# Comment on 55.7.3.2

**Richard Mei**  
**SYSTIMAX® Solutions**  
**May 18, 2005**

Pair-1 IL & PSAFEXT (Closet End)

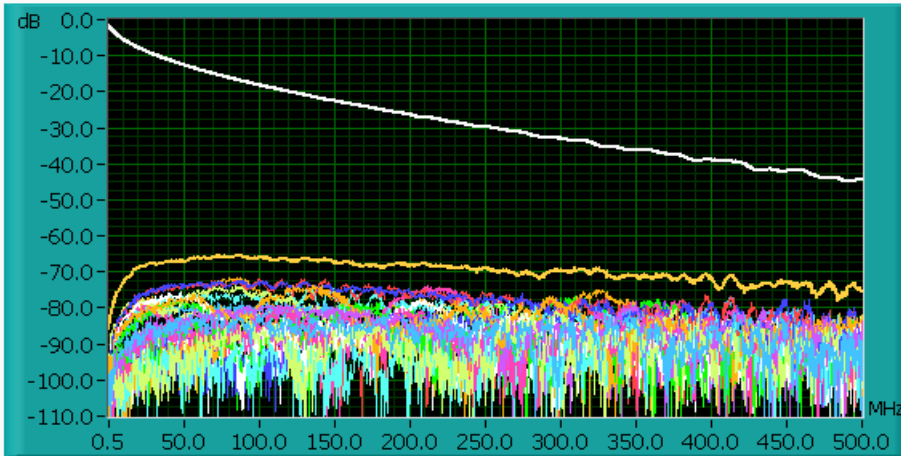
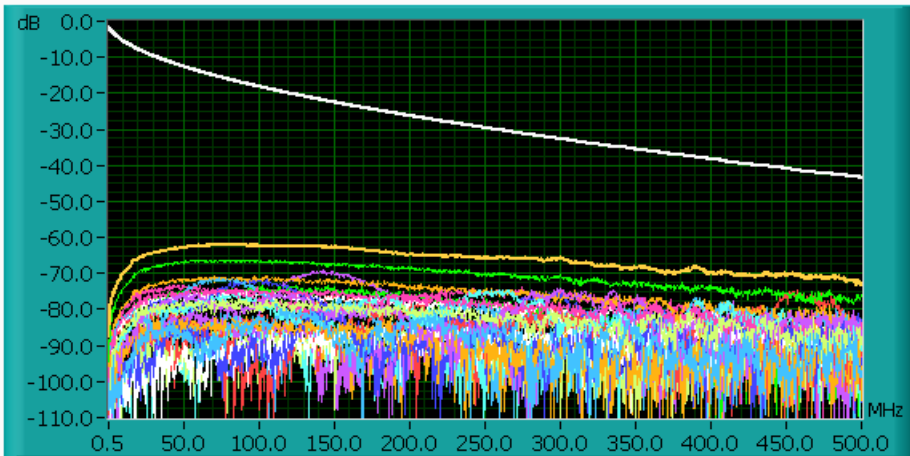
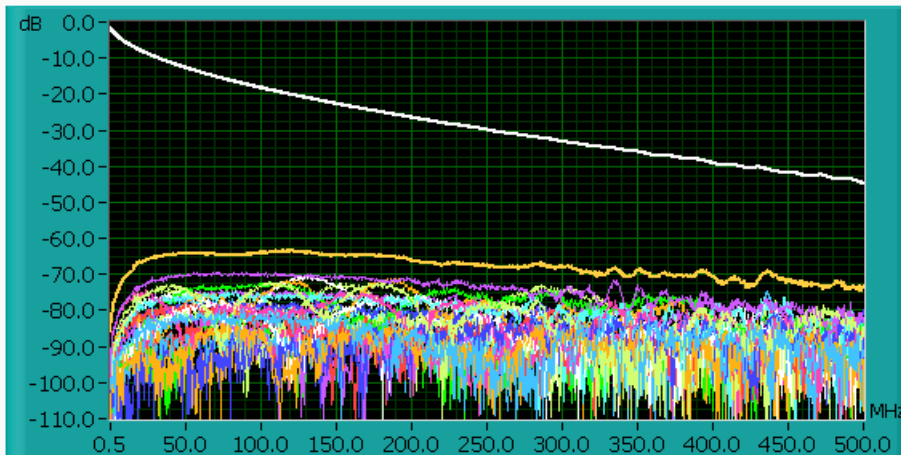
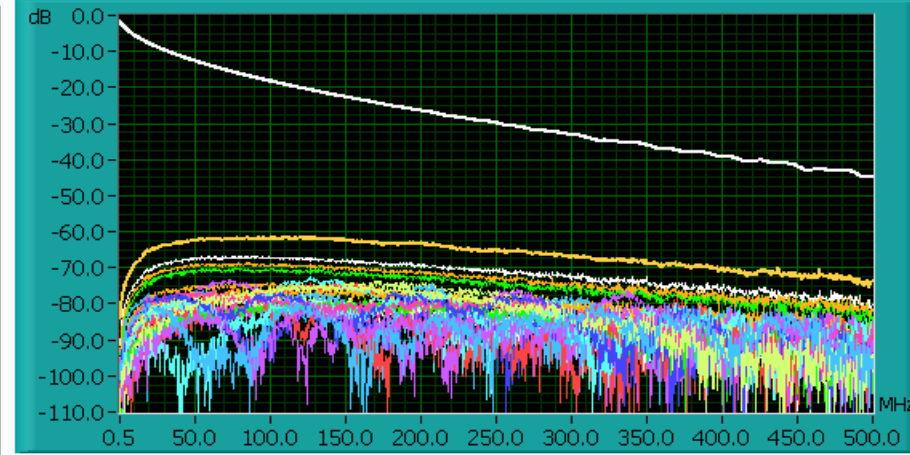
- **PSAFEXT is close to 70dB at high frequency for 100m 6x1 channels**
- **This level is low and can be ignored**

Pair-4 IL & PSAELFEXT (Closet End)

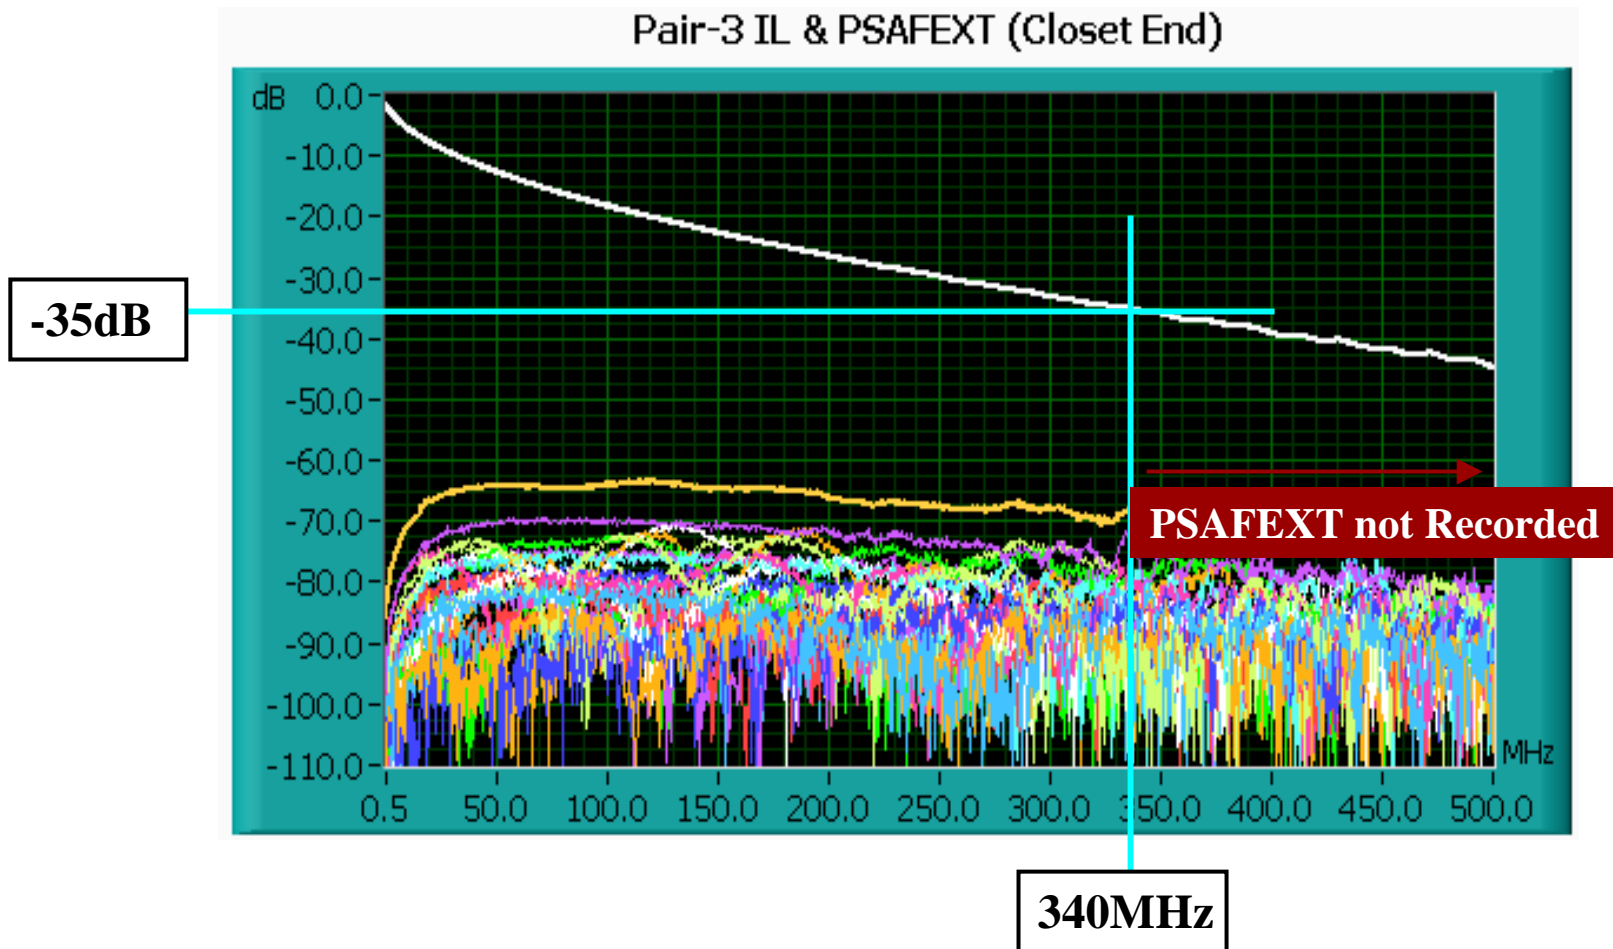
- Propose to implement an IL cap at  $-35\text{dB}$
- PSAFEXT will not be recorded beyond the corresponding frequency

Pair-1 PSAELFEXT (Closet End)

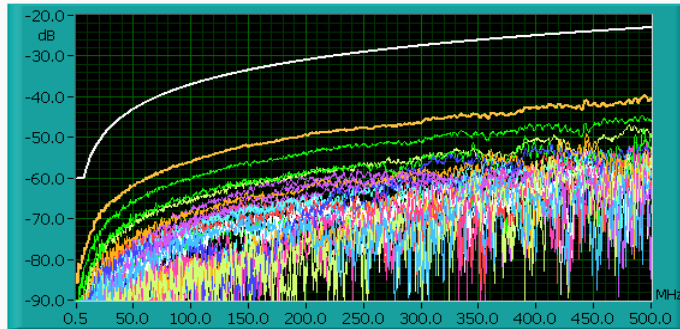
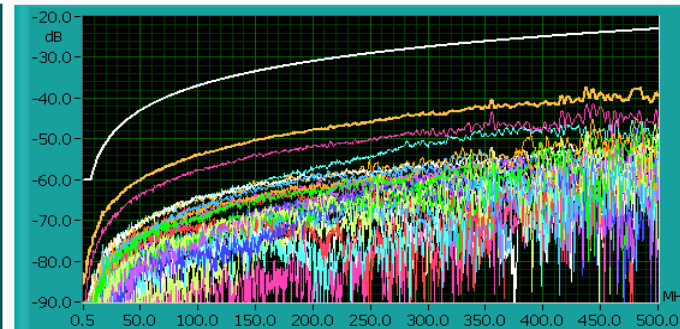
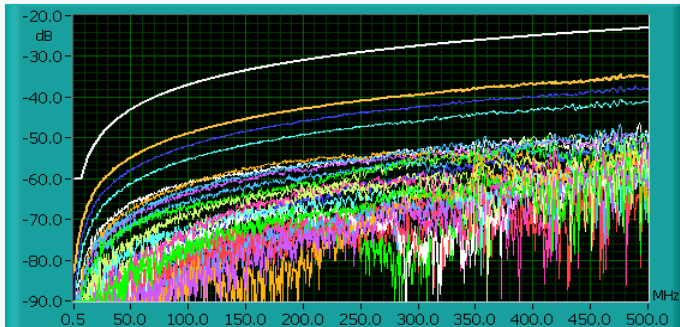
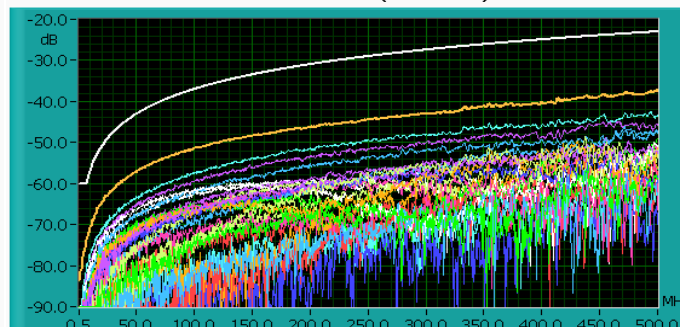
- **No impact on PSAELFEXT calculation for short 6x1 channels**
